RE: AURORA FOOD STORE
 2000 ANAQUOD ROAD
 REGINA, SK
 Commission No. 2445

RE: Rachelle Bery Lighting/Power

Project: Aurora Grocery Store
2000 Anaquod Road, Regina, Saskatchewan
Subject: Rachelle Bery Department Lighting and Power
Date: 2025.06.25

Subject: Rachelle Bery Department Lighting and Power
References: Electrical Drawing E0.2 – Schedules
Electrical Drawing E1.0 – Floor Plan – Lighting
Electrical Drawing E2.0 – Floor Plan – Power

SHEET TITLE:
**FLOOR PLAN -
LIGHTING**
COMMISSION NUMBER:
2445
SHEET NUMBER:
E.10

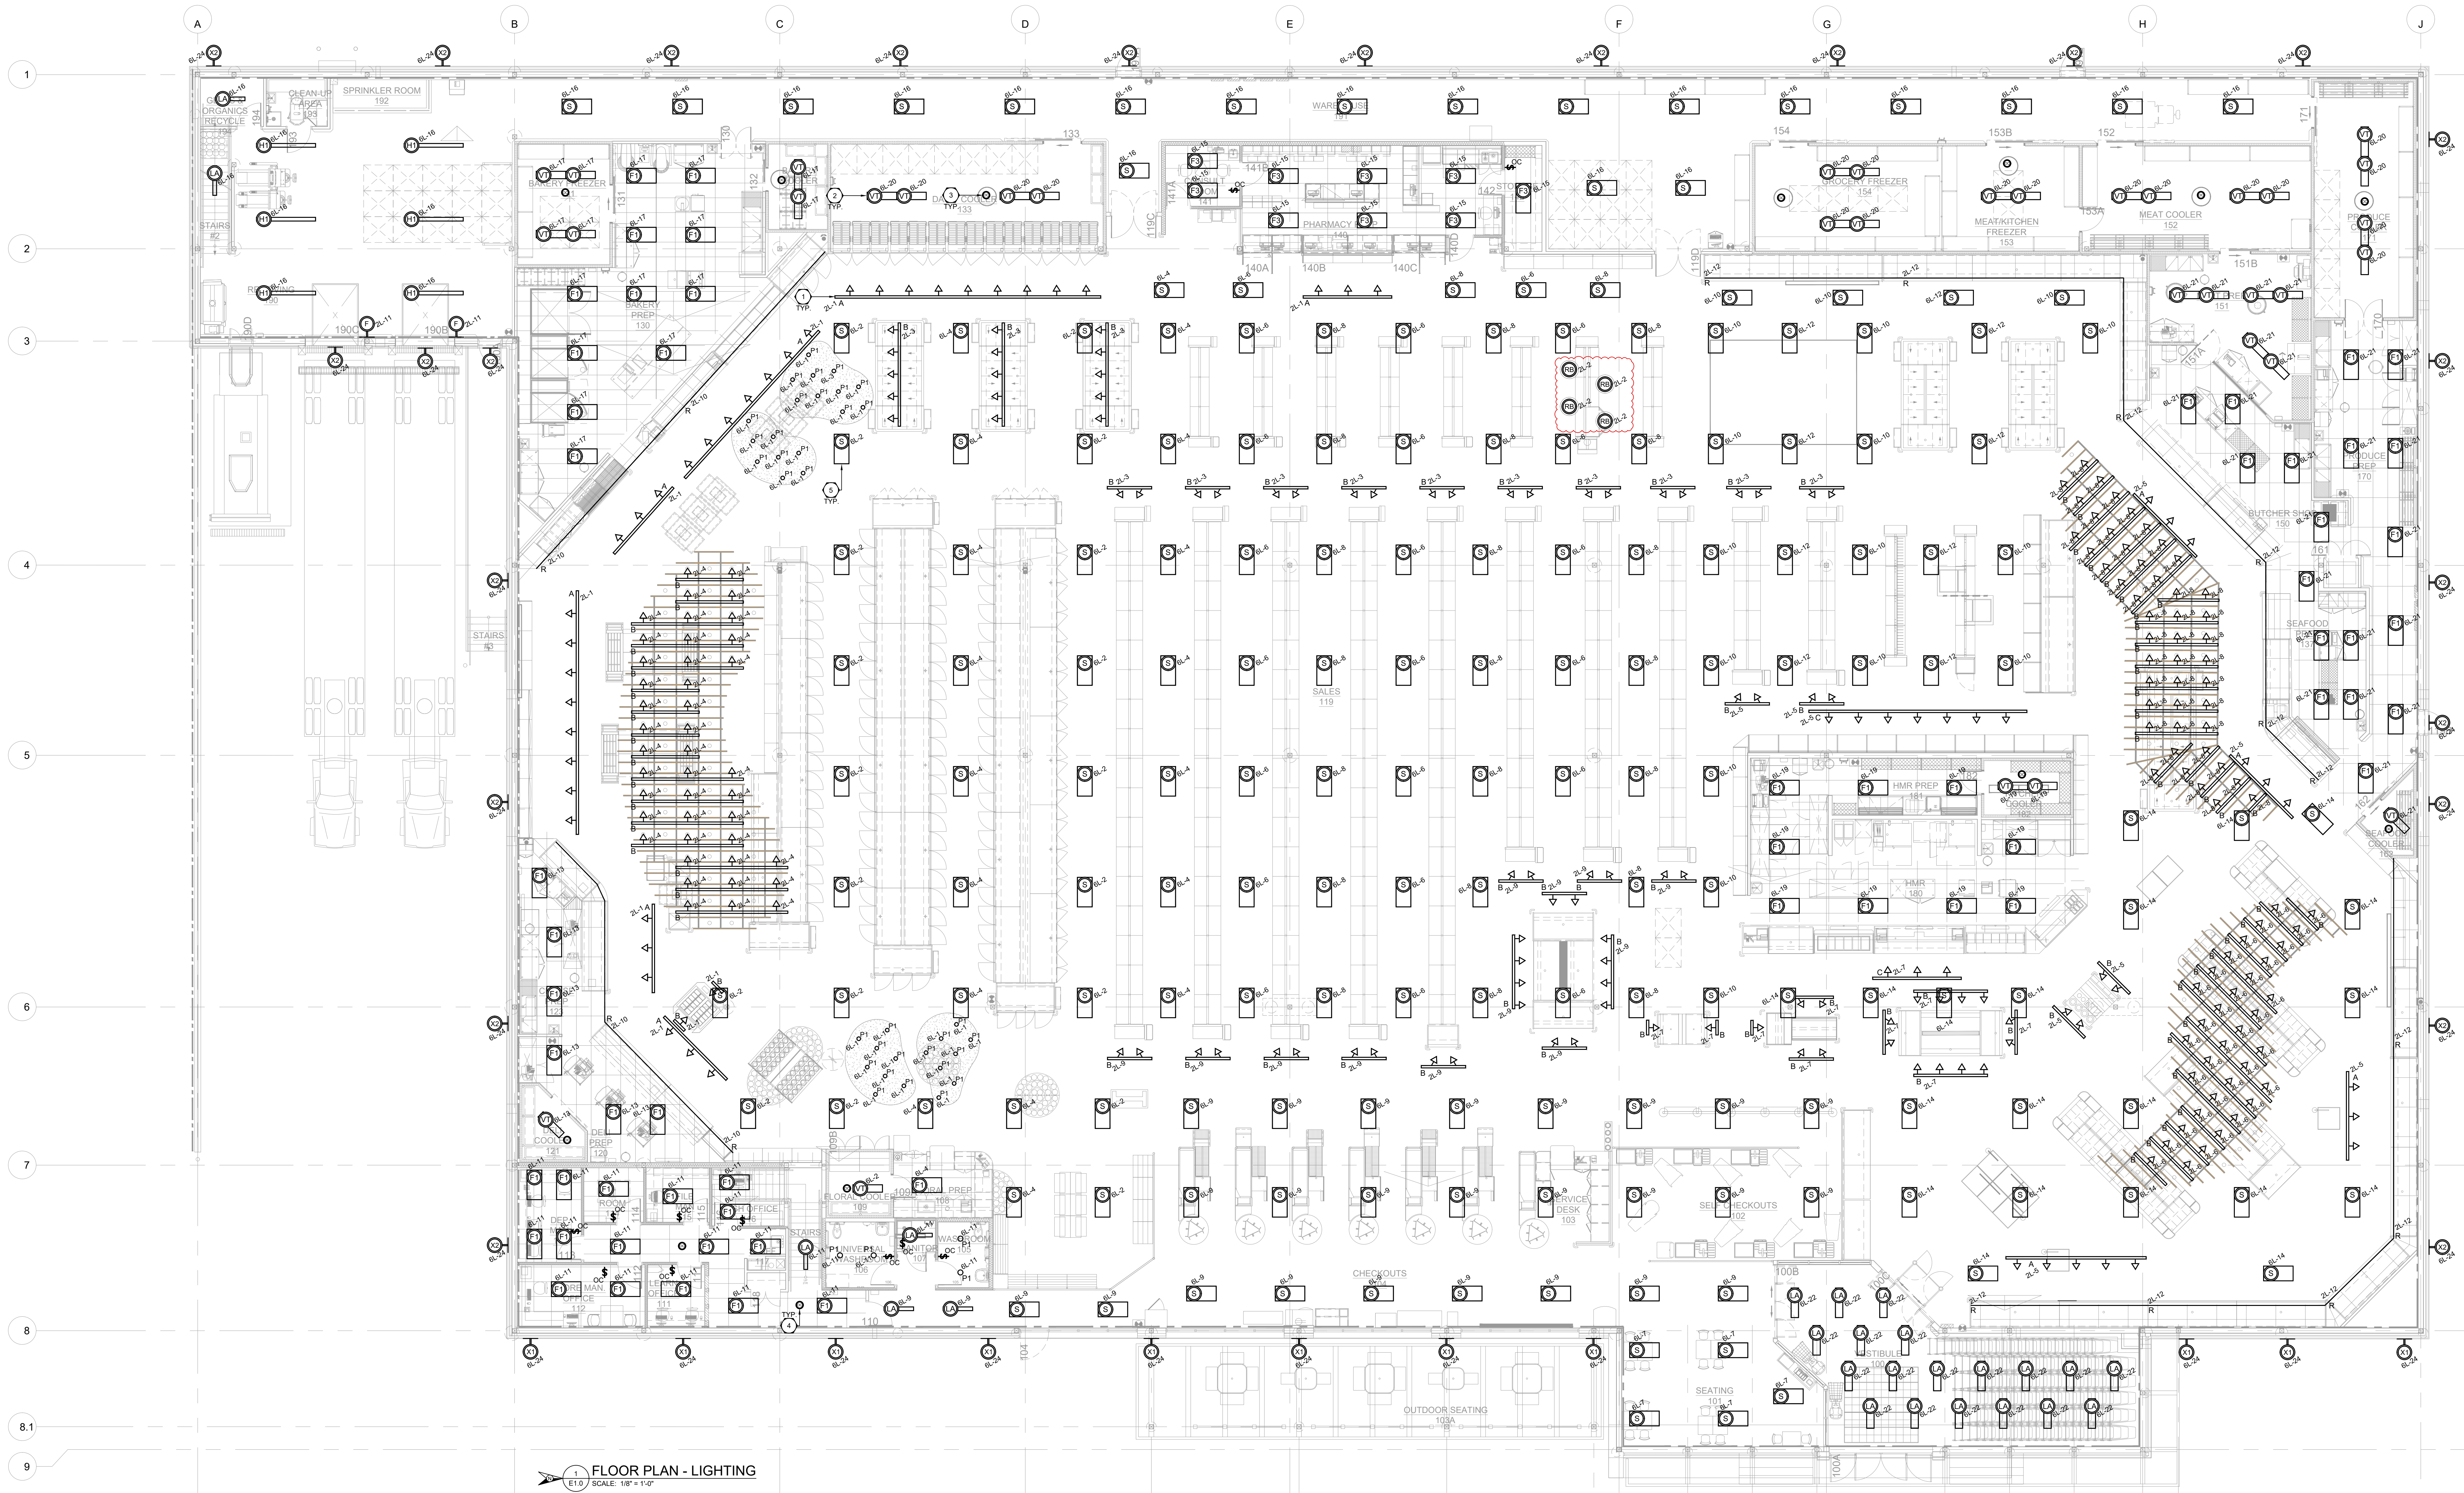
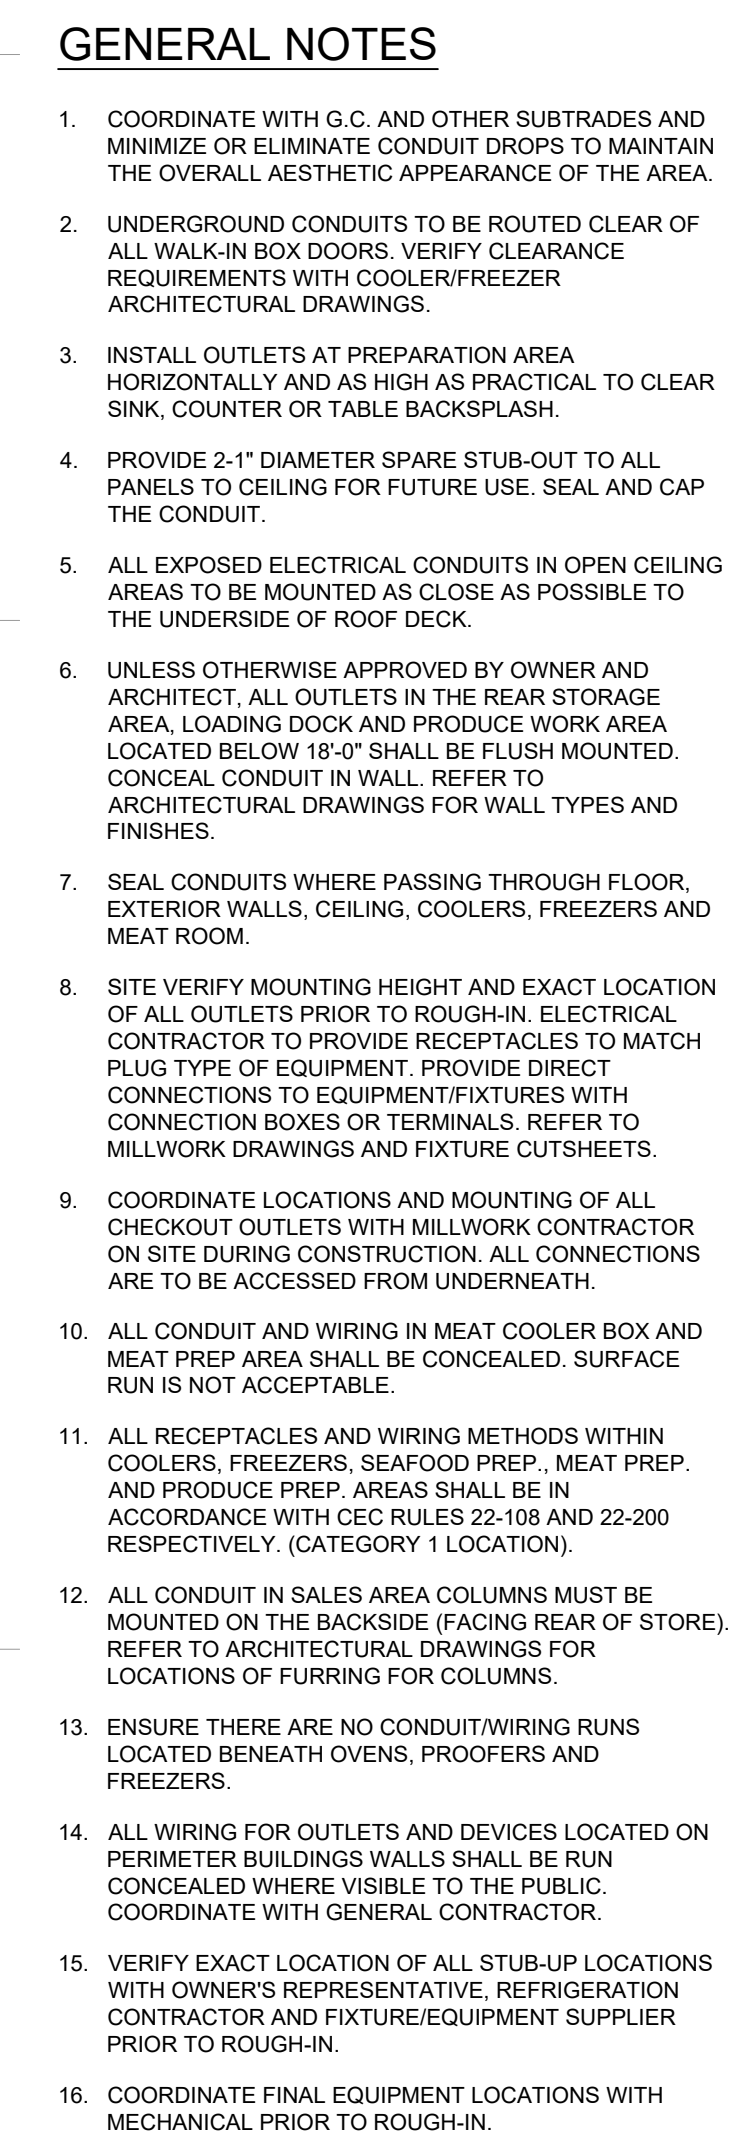
1. Refer to attached drawing E0.2 for one(1) additional 15A-1P added to panel '2A' for the Rachelle Bery light box receptacles.
2. Refer to attached drawing E1.0 for four(4) additional Type RB fixtures added. New fixtures to be wired to circuit '2L-2', previously allocated as a spare circuit.
3. Refer to attached drawing E2.0 for two(2) receptacles added for the Rachelle Bery light boxes and are to be wired to circuit '2A-38'. Specific note 36 is added to drawing E2.0 and states the following:
 - 3.1. 'RECEPTACLES FOR SHELVING LIGHT BOX. RECEPTACLE TO BE MOUNTED BEHIND LIGHT BOX. CONFIRM EXACT REQUIREMENTS WITH MANUFACTURER'S LITERATURE AND RACHELLE BERY DESIGN PACKAGE.'
